May 15, 1980

TO: Mr. Bruce Gallaher, Geohydrologist
Water Pollution Control Bureau
Environmental Improvement Division
P.O. Box 968
Santa Fe, New Mexico 87503

FROM: Dr. Stephen G. Wells, Consultant
Department of Geology
University of New Mexico
Albuquerque, NM 87131

SUBJECT: Comments on Groundwater Discharge Plan & Site Visit-
Mt. Talyor Uranium Mill Project, Gulf Mineral Resources

Figure 1. Threshold relationship between gullied and ungullied valley floors in several drainage basins of northwest Colorado. (From Patton and Schumm 1975, with permission of the Geologic Society of America)

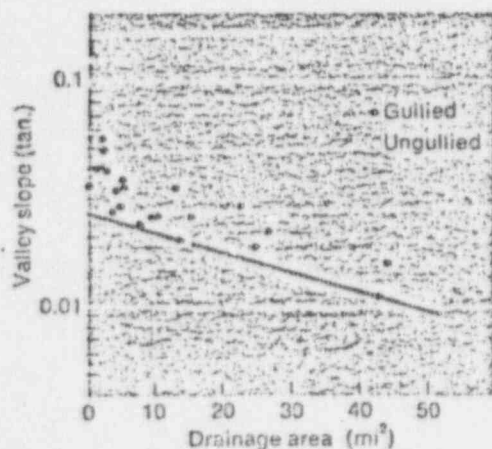
The lack of headward cutting and incising arroyo systems suggests base level stability over the past tens of years. It appears that runoff from the trench area is dominated by sheetwash (unchannelized flow) rather than channelized flow. The lack of arroyo cutting in this portion of the La Polvadera Canyon probably is not due to a lack of precipitation as suggested in the Groundwater Discharge Plan (page II-11); rather, it may be related to local geomorphic and hydrologic conditions. One possibility for the lack of arroyo cutting is given by the relationship between valley slope and drainage basin size (see Fig. 1). Low valley slopes for a given drainage basin are typically ungullied; whereas, steep valley slopes for the same basin size are gullied (see Fig. 1). The valley slopes of the

the trench area may have slopes below the threshold shown in Figure 1, thus are not incised. Oversteepening of the valley slopes result from aggradation (local) via stream avulsion or fan deposition. Since the trench area is dominated by pediment surfaces (erosional) rather than depositional surfaces (e.g. alluvial fans) and runoff is unchannelized, valley oversteepening would not be expected.

Figure 4

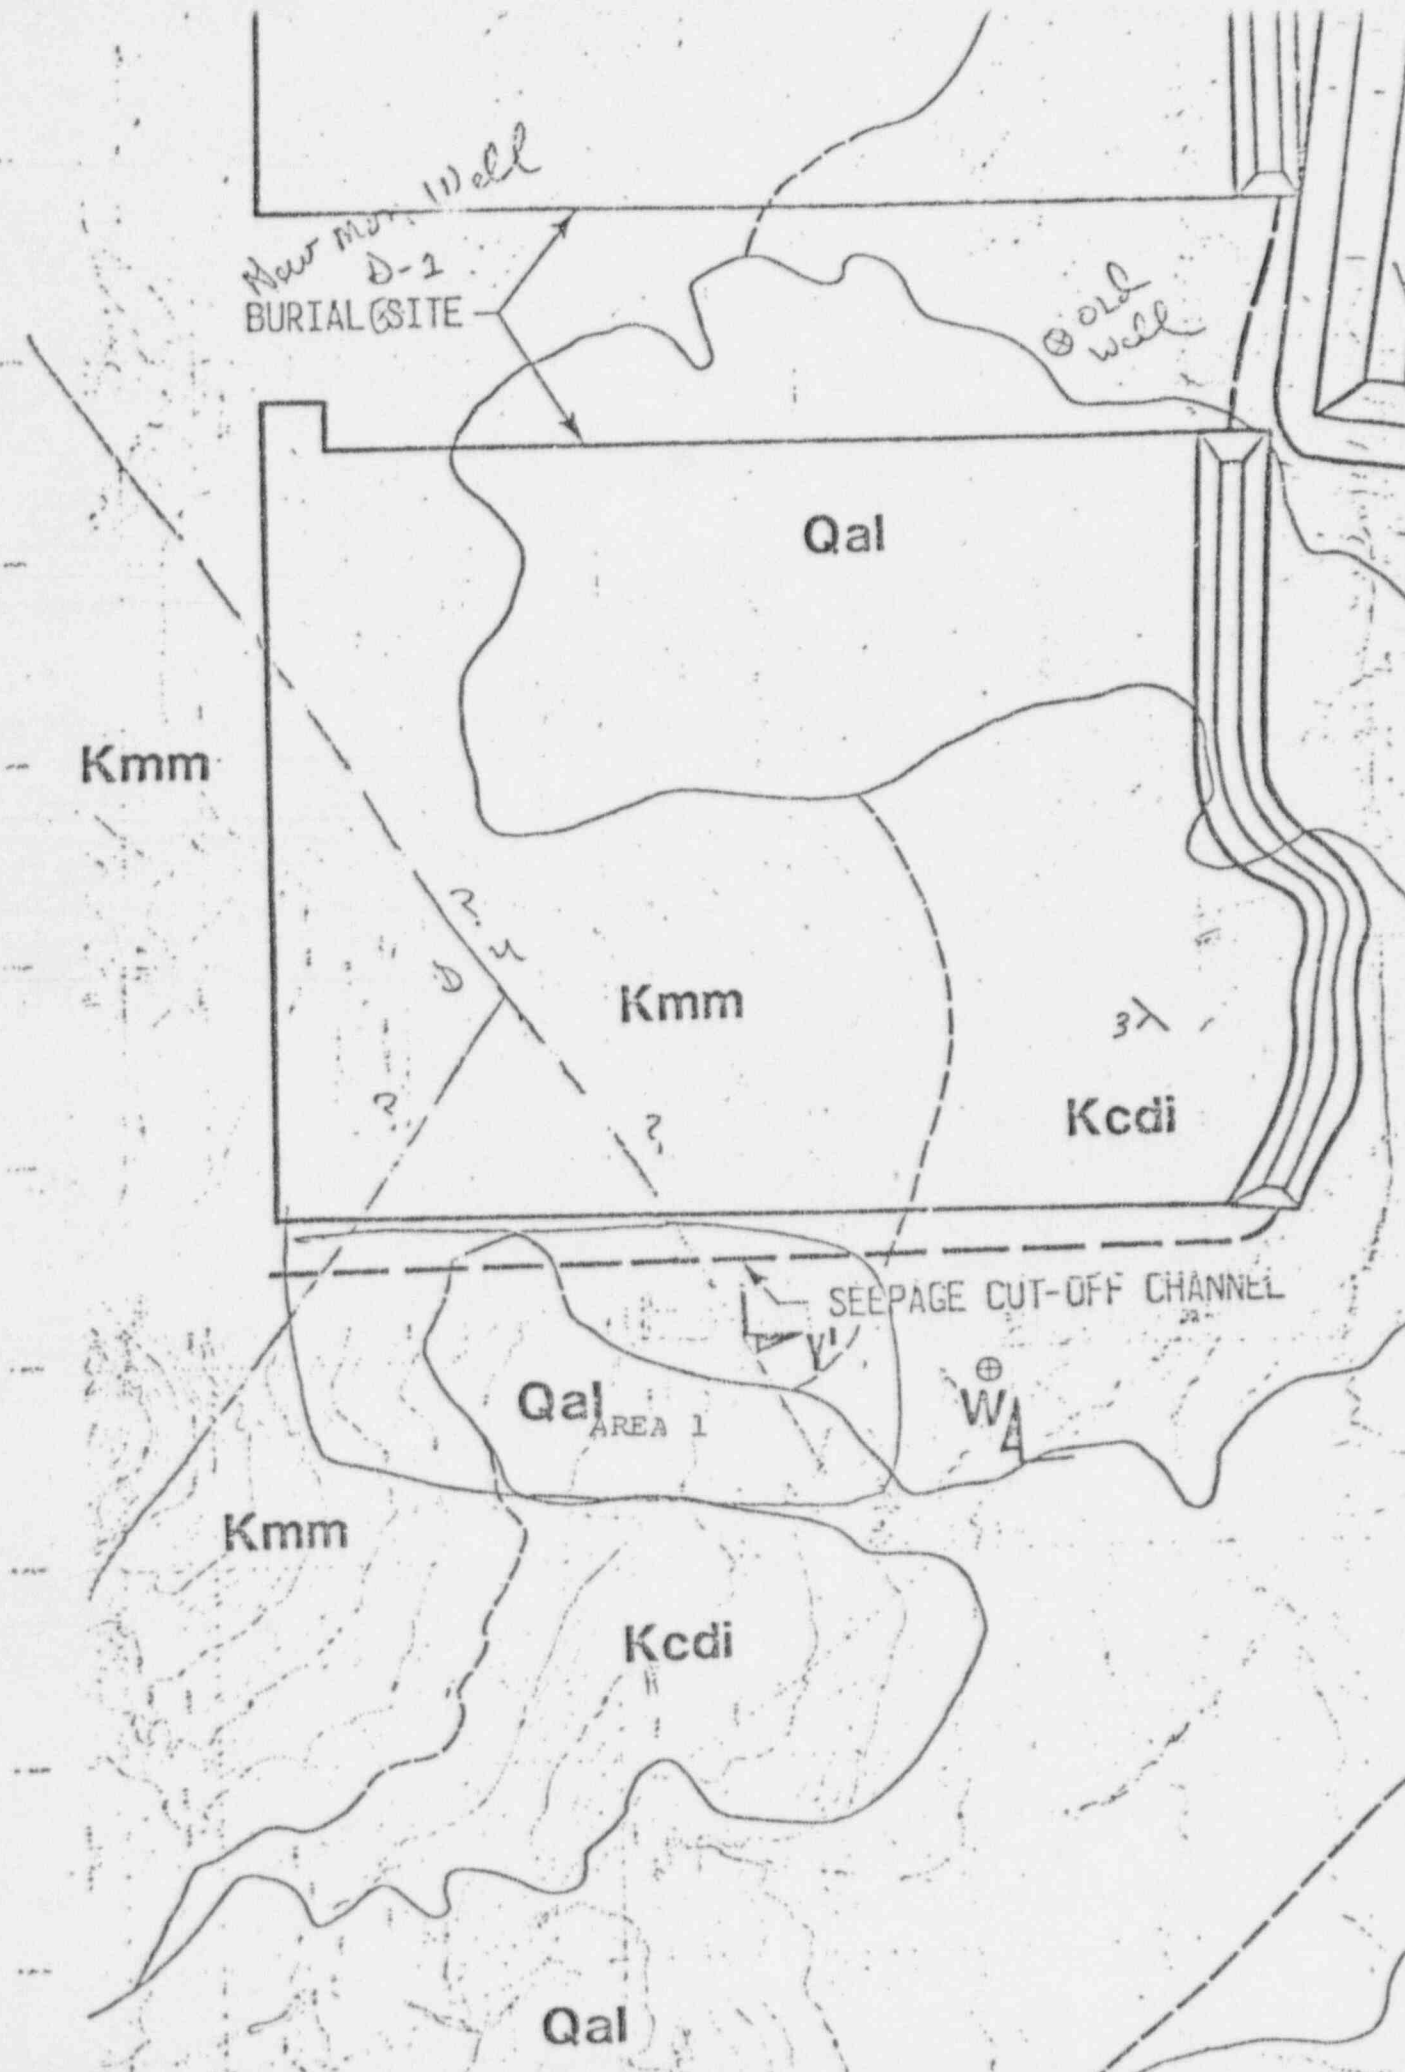
I have enclosed two figures (Figures 3 and 4) which illustrate areas that may be susceptible to accelerated erosion due to natural conditions or due to post-reclamation landscape geometry. Area 1 on Figure 3 may have gully incision if the reclaimed land increases the slope leading into this valley. A similar situation may occur in area 2 on Figure 4. A map illustrating the general geometry of the reclaimed landscape is needed to further evaluate this potential problem.
